# 66<sup>TH</sup> MACAU GRAND PRIX

**Document** 11

## **BULLETIN 04 – DRS Actuator Shim Pack**

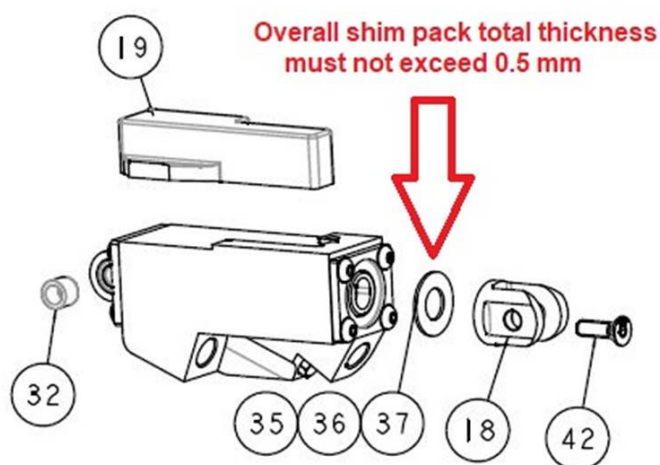
**For SAFETY REASONS the maximum thickness of the DRS actuator shim pack is now 0.5 mm** (see drawing here below).

YOU MUST CHECK THAT ALL CARS CONFORM TO THIS SPECIFICATION BEFORE MACAU 2019 QUALIFYING 1.
